Our Ref
PLAN-027168
Date
04/04/2019

Proposal: Two storey extension.
Site: 49 Warren Way, Barnham, PO22 0JX.
EG/16/19/HH

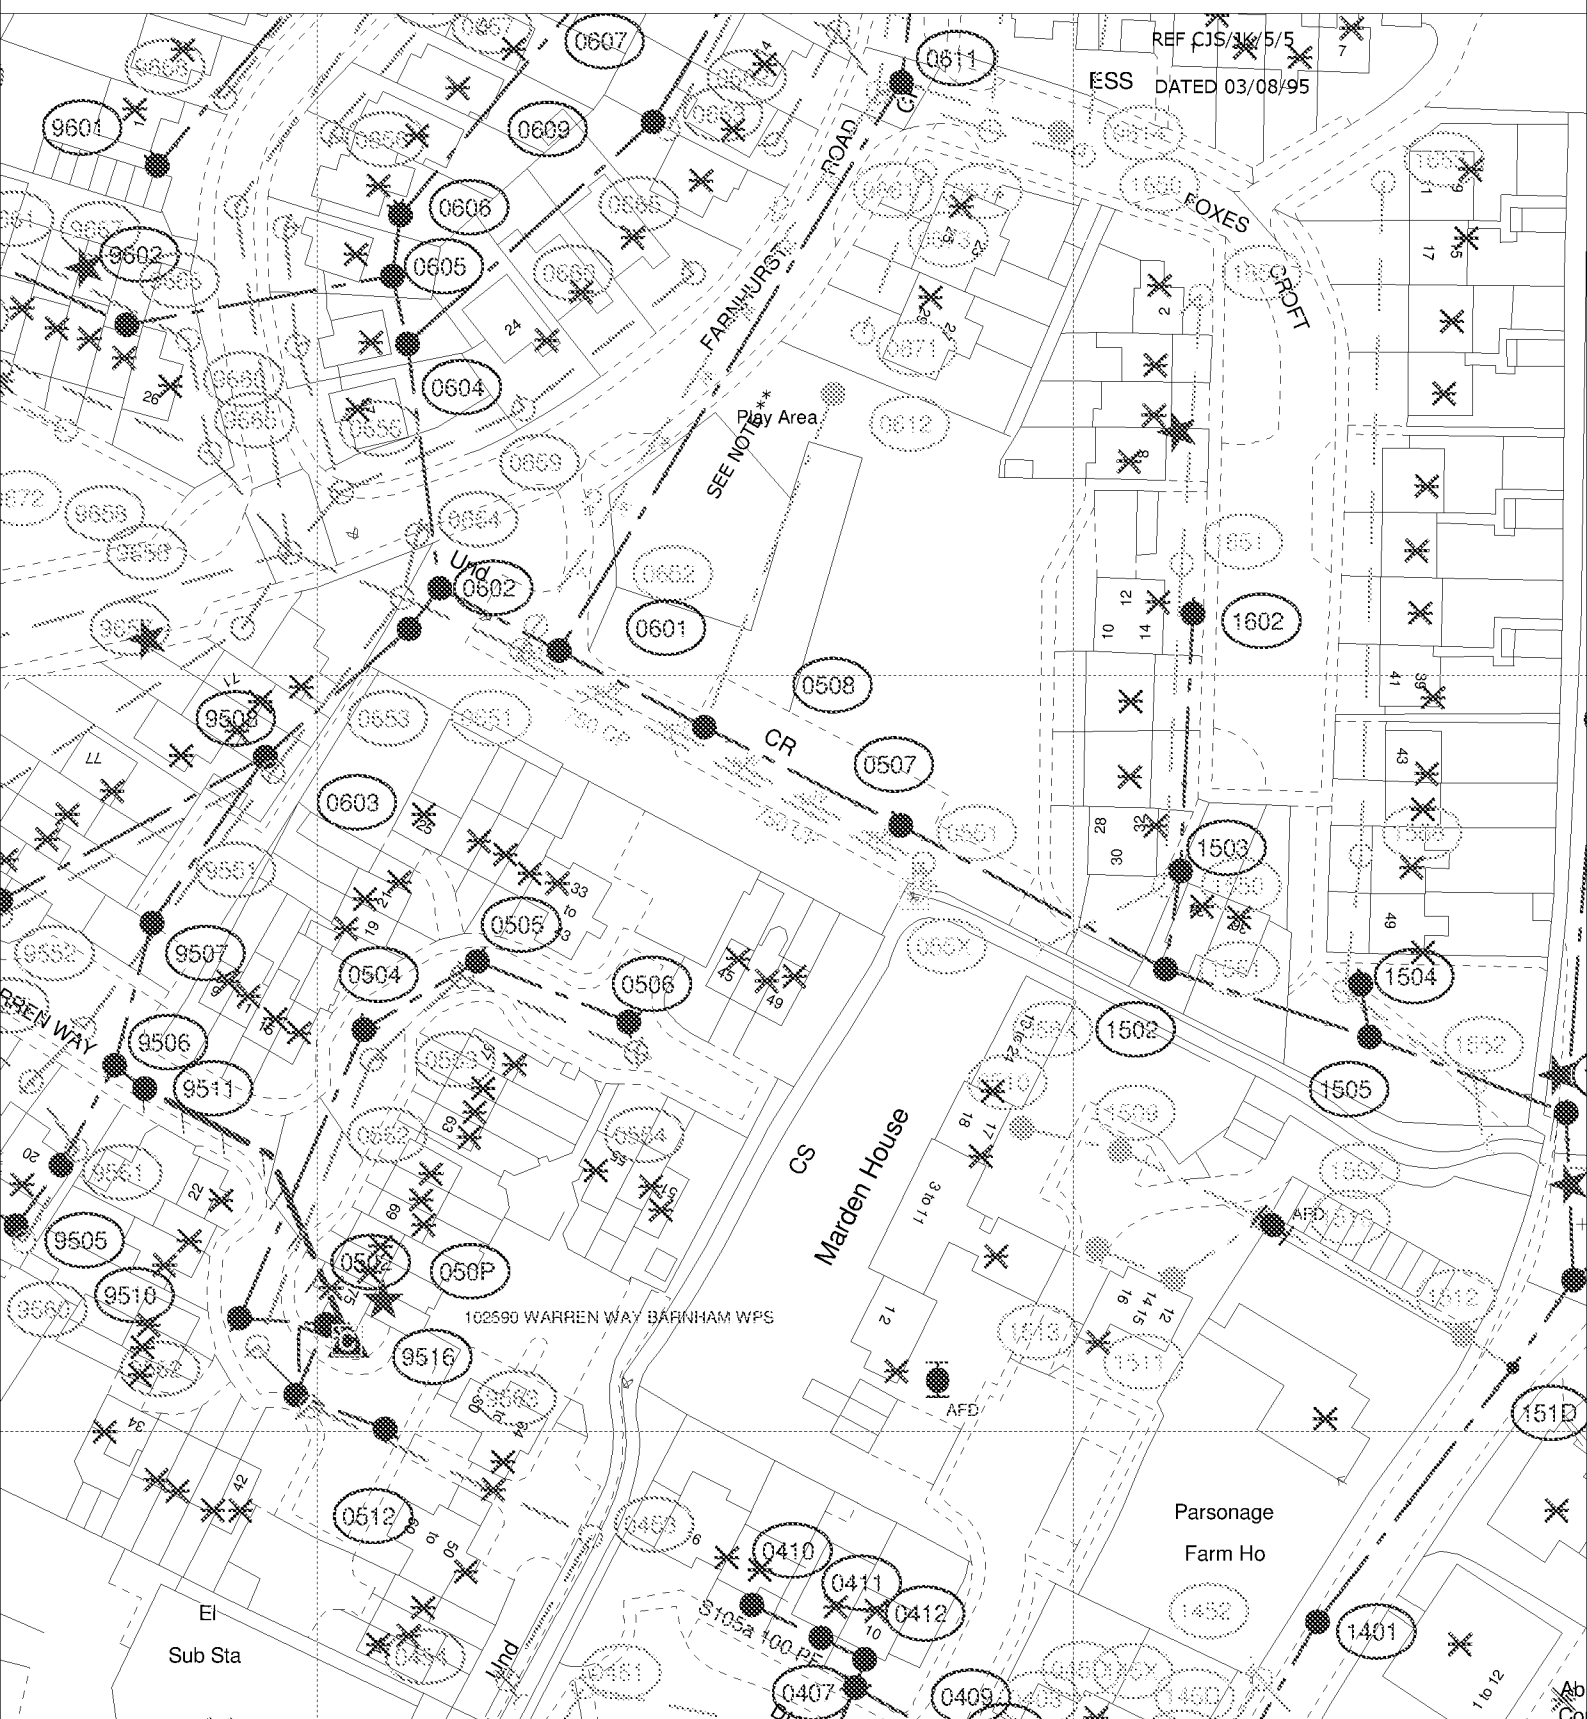
Due to surface water inundation issues in the Lidsey Catchment "The applicant is advised to adopt, where appropriate, the measures in the table "Practical measures to reduce the potential impacts of development".

Developer should look to protect the public sewerage system from inundation and infiltration, which contribute to flooding in unfavourable conditions.
